City of Manhattan Beach

SUBJECT: Discussion of Construction Issues for the 2002-05 Street Improvement Project and Approve Appropriation of \$54,000 for Change Order No. 1 to Griffith Company

2002-2005 Street Improvement Project

4" PCC ROLLED CURB AND GUTTER

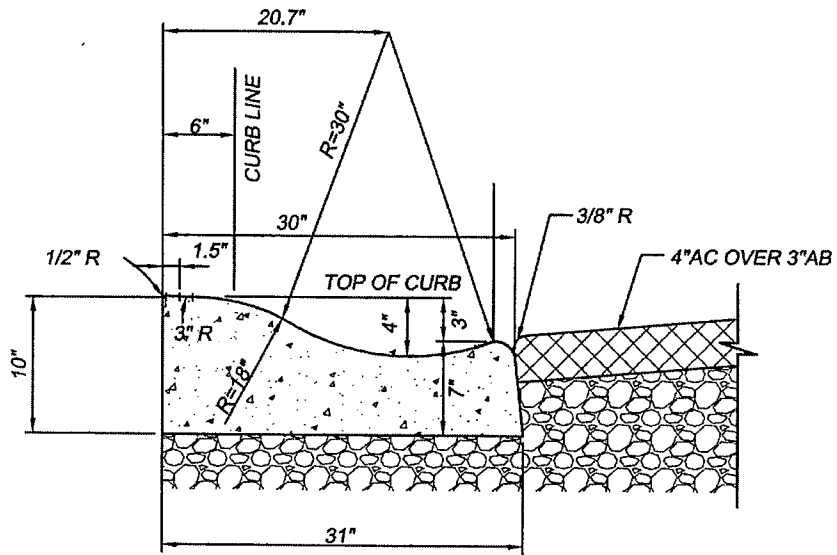
Some residents have requested that the profile of the rolled curb be modified so that it is not as high as is currently being constructed. The current rolled curb profile is 4" high from the flow line to the top of the curb and 1" high from the flow line to the edge of the street. Thus the top of the rolled curb is 3" higher than the edge of the street grade. As mentioned previously, reducing the height of the rolled curb reduces the surface drainage capacity of the street. This may be especially critical for properties that are below the grade of the street. For this reason although the rolled curb profile may be reduced the Public Works Department does not recommend reducing the curb height to less than 3" due to concerns regarding surface drainage.

- Whether to increase the 2-foot “pave back” area for reconstruction of the encroachment area
- Whether the Contractor can continue to use the slip-form equipment on the current project or require the Contractor to use the form and place method; the form and place method will add approximately \$54,000 to the project cost
- Whether the rolled curb cross section should be reduced from a 4” height (measured from flow line to top of rolled curb)
